Traffic Engineering Letter

To	CREERA	Date	12 June 2026
Prepared by	Arthur Stamatou, Modus Senior Traffic Engineer	Approved by	Harj Singh, Modus Executive Director (RPEQ 22364)
Location	69 Landis Street, McDowall		
Subject	Response to Brisbane City Council (BCC) IR for a Proposed Multiple Dwelling Development		
Status	Further Items Response	Attachments	Appendix A: Development Plans Appendix B: Swept Path Assessment

Council Commentary

DRAWING NUMBER
MOD23398QLD - SK01

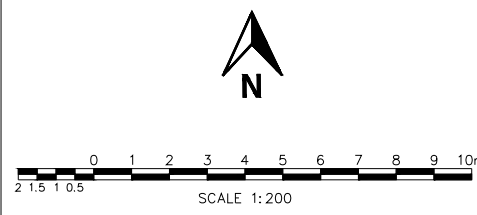
- b. The Refuse Collection Vehicle swept path analysis is to use the 10.24m Rear Loading RCV (As per BSD-3008-2) as specified in Table 3 of the Refuse PSP which demonstrates safe and efficient on-site servicing utilising a curb-to-curb turning radius of 9.757min. (Note this is the minimum requirement).*

- c. Demonstrate that proposed Servicing Bay/standing zone for refuse collection on the submitted plans and that it does not encroach into neighbouring property or impact on the aisle and through traffic of vehicles entering and exiting the site. Clearly demonstrate the standing zone for collection and collection area on the submitted plans.*

- d. The RCV bay/standing areas requires consideration to be giving to loading areas (minimum 1.5metre for refuse collection) as per Table 12 of the TAPS PSP.*

- e. Demonstrate that a B85/B99 car can pass the RCV during collection safely.*
- f. Confirm the minimum Garage door opening width complies with Table 19? Recommended garage widths for various driveway widths of the TAPS PSP. (note: the traffic report only references single width)*

b) A revised swept path assessment is provided in Appendix B using a 10.24m Rear Loading Refuse Collection Vehicle (RCV) in accordance with BSD-3008-2. The assessment demonstrates that the vehicle can safely and efficiently access, manoeuvre within and service the site utilising the required minimum curb-to-curb turning radius.

The swept path assessment demonstrates an informal refuse collection standing zone within the subject site/common-property access area, in accordance with Table 12 of the TAPS PSP.

The RCV standing zone is located wholly within the site and does not require the refuse collection vehicle to stand on Landis Street or encroach into adjoining private property. The standing zone is positioned to allow the RCV to undertake collection from the nominated bin storage/collection area and then exit the site in a forward direction.

d) The refuse servicing arrangement provides a minimum 1.5 m loading/collection area adjacent to the RCV standing position, consistent with the refuse collection area requirements identified in Table 12 of the TAPS PSP.

A review of the internal access arrangement confirms that simultaneous passing of a B85/B99 vehicle and the RCV is not achieved while the RCV is standing for refuse collection.
